# Work Order ID 73725

Item Name: Crosstube Aft

Reference: REWORK TO CHANGE 4

DRAWING NO. D206-667-243	TITLE CROSSTUBE ASS'Y (206L HIGH AFT)	REV. C	<b>DART AEROSPACE LTD ENGINEERING ORDER</b>		D.E.O. NO. D206-667-243-C-1	SHEET NO. SHEET 1 OF 1	SCALE NTS
DRAWN <i>q</i>	CHECKED <i>ASS</i>	MFG. APPR. <i>RB</i>	APPROVED <i>MP</i>		DE APPR. <i>#</i>		
DATE 11.07.15	DATE 11.07.20	DATE 11.07.21	DATE 11/07/21		DATE 11.07.21

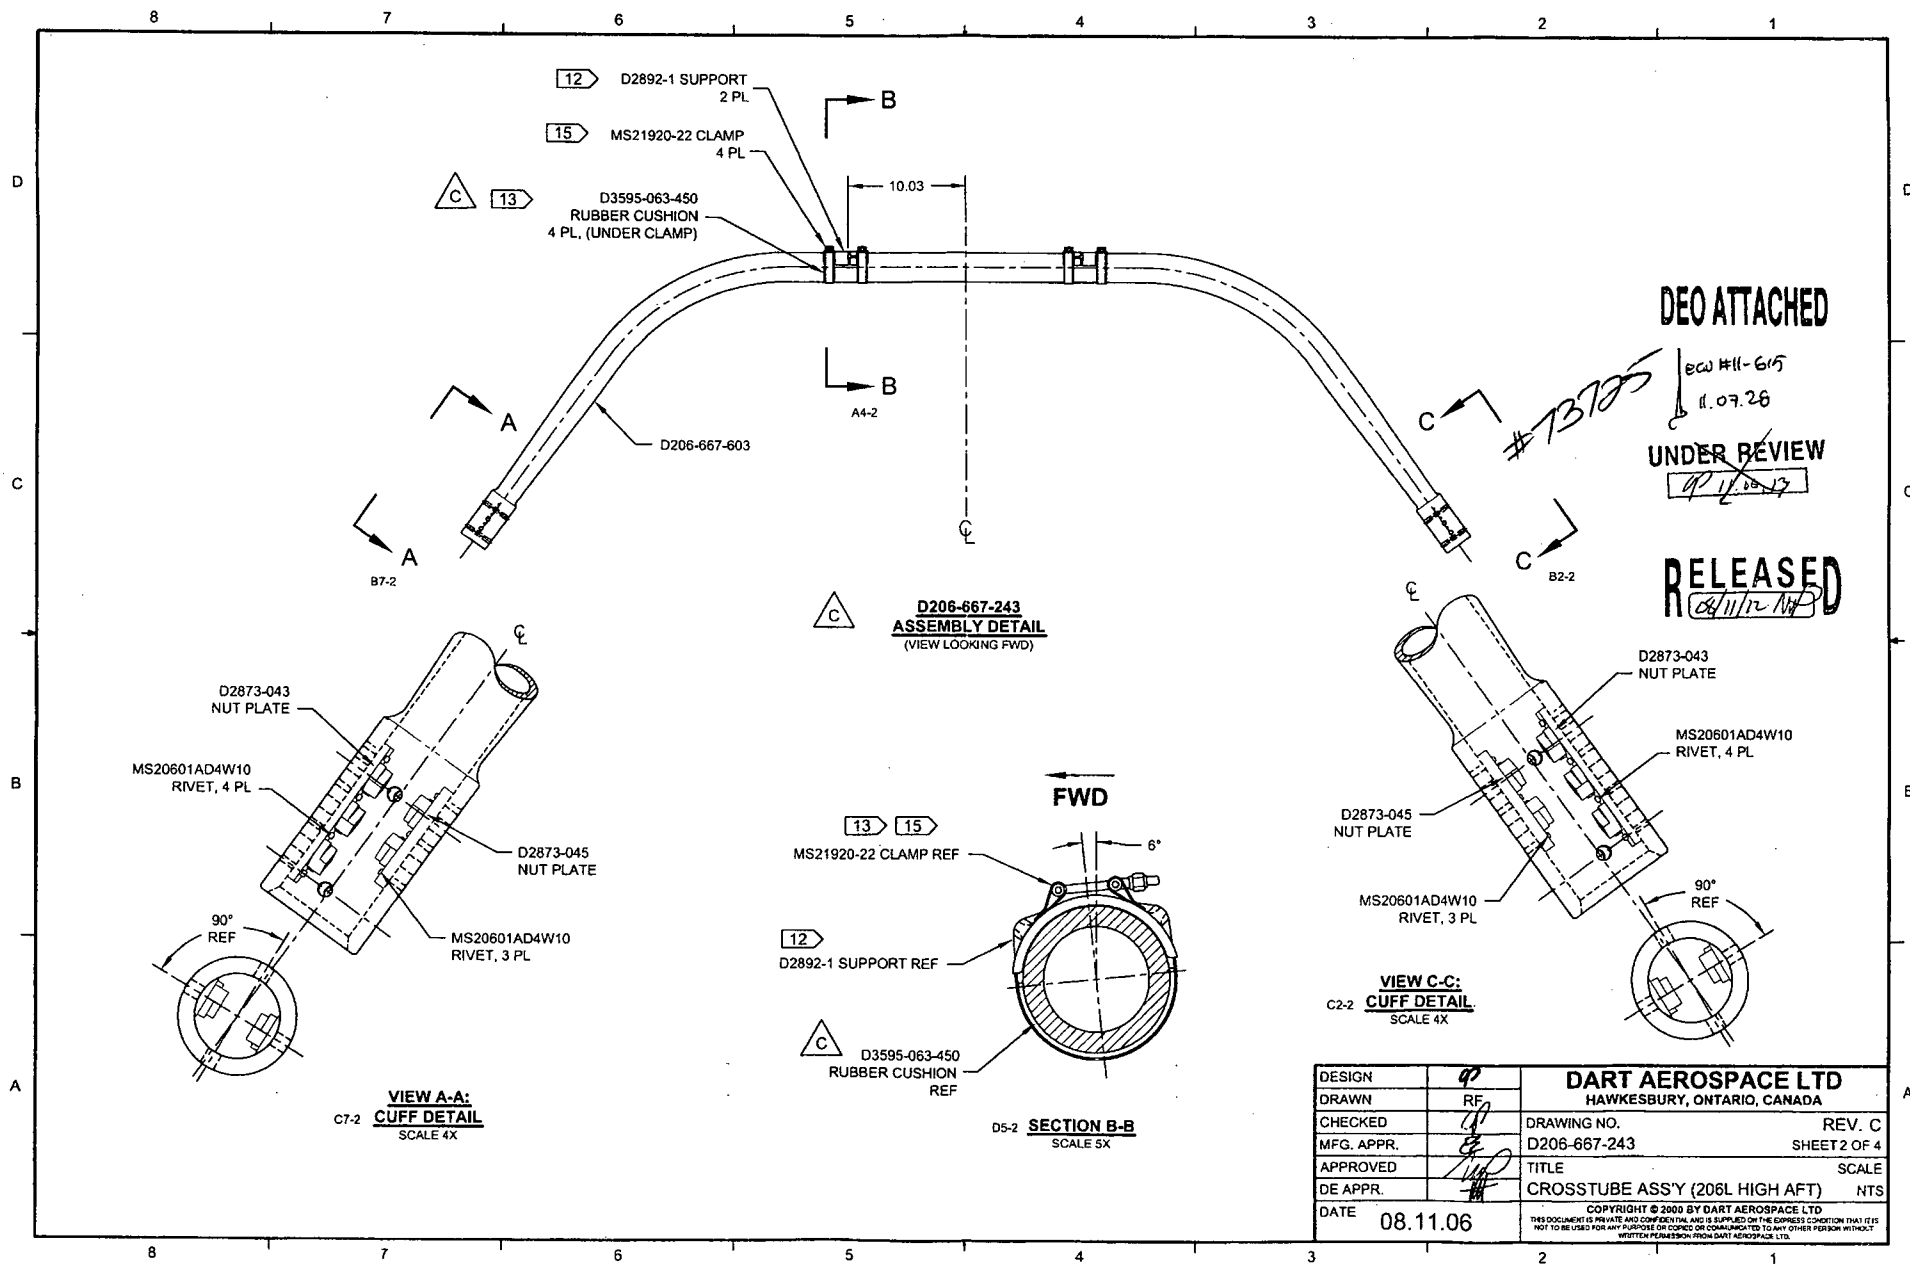
**PURPOSE:**

REPLACE MAGNOBOND WITH PROSEAL.

Item	Qty -243	Part Number	Description
9	A/R	PROSEAL 890 B-2	SEALANT, AMS-S-8802 CLASS B-2

9	A/R	MAGNOBOND 6398	ROCKWELL SPECIFICATION RBO-120-023 ADHESIVE (TEXTRON/BELL SPEC. 299-947-100, TYPE II, CLASS 2 ADHESIVE)
---	-----	----------------	---

NOTE 12 & 15, SHEET 1 IS AMENDED AS FOLLOWS:

12) TO INSTALL D2892-1 SUPPORT: ABRASE MATING SURFACE OF SUPPORT AND CROSSTUBE WITH 180-GRIT SANDPAPER AND REMOVE RESIDUE WITH MEK (OR EQUIVALENT). APPLY A 0.04" TO 0.07" THICK LAYER OF PROSEAL 890 CLASS B-2 (OR AMS-S-8802 CLASS B-2) SEALANT TO MATING SURFACE OF SUPPORT.

15) TORQUE CLAMPS 80 TO 100 IN-LB. ENSURE AT LEAST 1.5 THREADS SHOWING IN SAFETY AND THAT NUT HAS NOT BOTTOMED-OUT AFTER TORQUING. **PRIOR TO PACKAGING, RE-CHECK TORQUE ON CLAMPS AFTER PROSEAL 890 SEALANT HAS CURED FOR 72 HOURS.**

12) INSTALL D2892-1 SUPPORT USING 0.03" TO 0.08" THICK LAYER OF MAGNOBOND 6398 PER QSI 015. LET CURE FOR 12 HOURS AFTER INSTALLATION AND PRIOR TO PACKAGING.

15) TORQUE CLAMPS 80 TO 100 IN-LB. ENSURE AT LEAST 1.5 THREADS SHOWING IN SAFETY AND THAT NUT HAS NOT BOTTOMED-OUT AFTER TORQUING.
